## MEMORANDUM

<b>DATE:</b>	2021-11-16	<b>RWDI Reference No.:</b> 2104113
<b>TO:</b>	Justin Hart, P.Eng., GSI Project Manager – Major Projects City of Pitt Meadows	<b>EMAIL:</b> JHart@pittmeadows.ca
<b>FROM:</b>	Matthew Johnston, P.Eng. Ben Coulson, P.Eng., M.A.Sc. Laura Dailyde, P.Eng., PMP	<b>EMAIL:</b> matthew.johnston@rwdi.com <b>EMAIL:</b> ben.coulson@rwdi.com <b>EMAIL:</b> laura.dailyde@rwdi.com
<b>RE:</b>	<b>Modelling, Analysis and Mitigation Summary City of Pitt Meadows Pitt Meadows, BC</b>

*Picture 1: Barrier wall at 19034 McMyn Road (R2). Barriers must be free of gaps and cracks to be effective.*

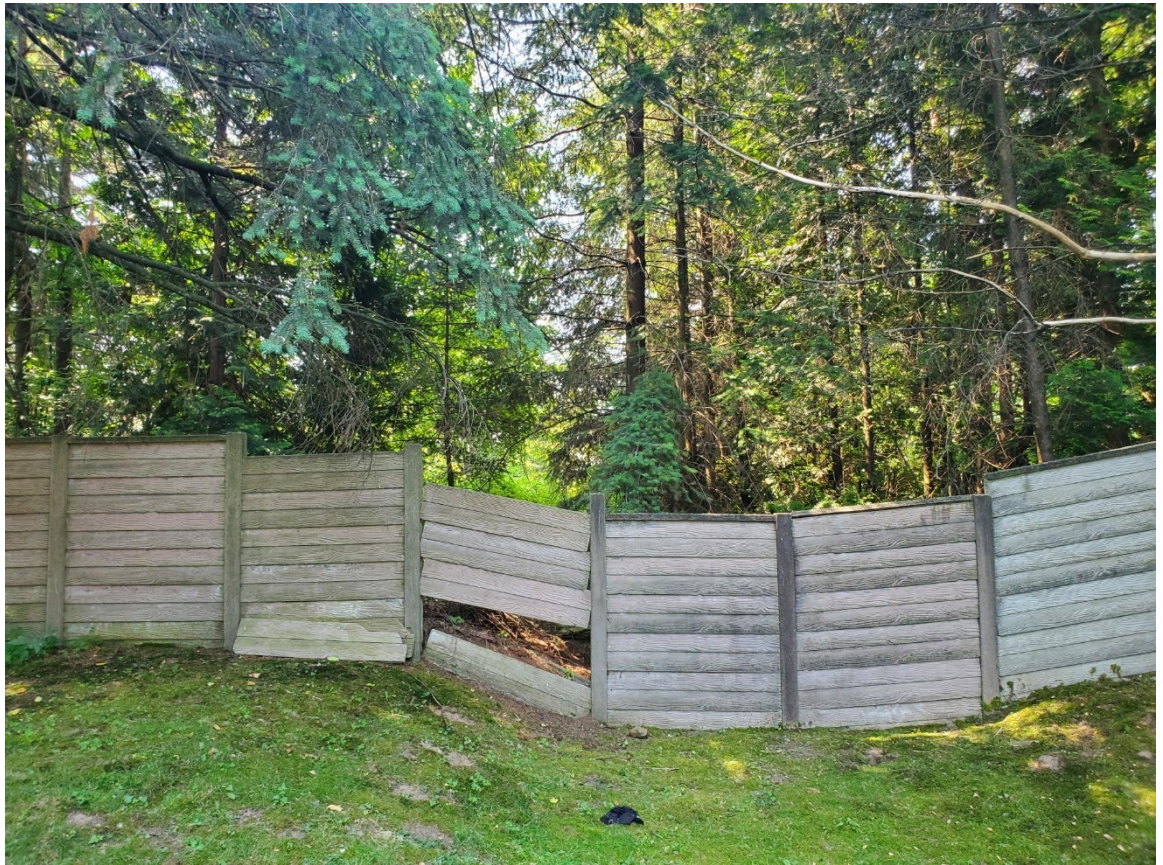
The Stantec survey indicates that the sound walls are generally in good condition with some gaps. RWDI did not complete a detailed existing barrier review but did find examples of walls in good condition based on field spot checks. RWDI did however find some walls which are in disrepair and will have limited effectiveness for noise reduction. Picture 1 shows the condition of a barrier wall located close to R2 (19034 McMyn Road), approximately 350 m west of the Harris Road crossing.

The modelling considers the physical dimensions of all proposed barriers, including local elevation, barrier height, and propagation around the ends of walls where the walls may be non-continuous (e.g., segmented). Such gaps will not make noise levels worse beyond (e.g., no amplification, directing or focusing effect). Continuous barriers will generally provide a greater attenuation for more receivers compared to barriers that are “segmented” (i.e., built with gaps in some sections). Additional barriers and higher barriers will reduce sound levels in the community if designed and installed appropriately. “Appropriate” means free of gaps and holes to ensure effectiveness (per Picture 1) and located in the
